Request for Class II Permissive Change

FCC ID: RI7FE910C04WW

Please be notified that we, the undersigned, Telit Communications S.p.A. declare that the reasons for this Class II permissive change are as below:

FE910C04-WW	
Radio equipment description	Radio module supporting 5G Rel17 + LTE Cat 4
Photo:

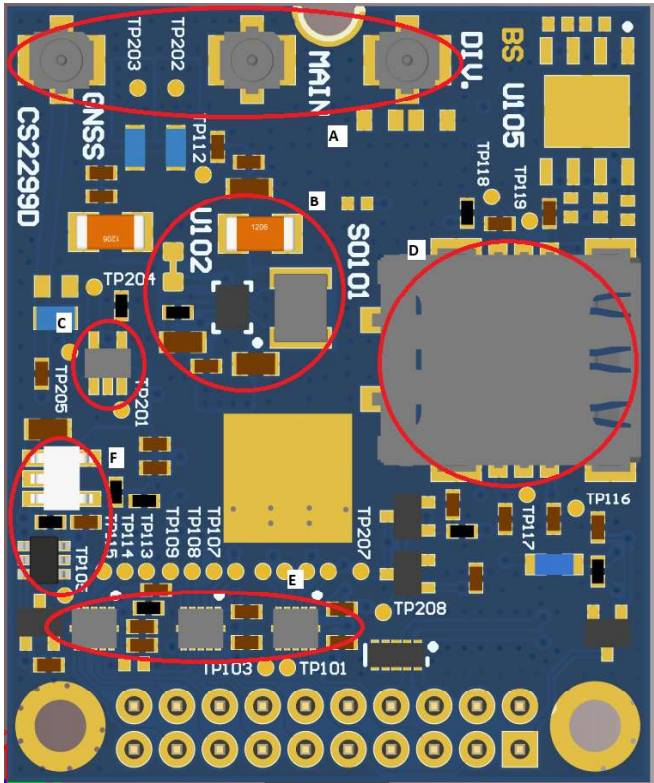
HVIN	Radio module main features	Differences with FE910C04-WW
FE910C04-WW	Supports Radio module supporting 5G Rel17 + LTE Cat 4	---
CMB100D0-WW	Provided by FE910C04-WW	HW: The FE910C04-WW radio module is soldered on a PCB to provide custom connector for plug-in in final host devices, and the new equipment obtained is named CMB100D0-WW. Referring to the picture below, the PCB hosts: A) U.FL connectors for RF cable plug-in (Main and GNSS) B) A buck-boost DCDC converter C) A LDO voltage regulator D) Nano-SIM holder or Nano-SIM+eSIM variant E) Communication signals level shifters F) LNA power supply and current limiter

FW: Reduce power for LTE Band 30/42/43/48 and NR band 30/48 via software.
--	--	---
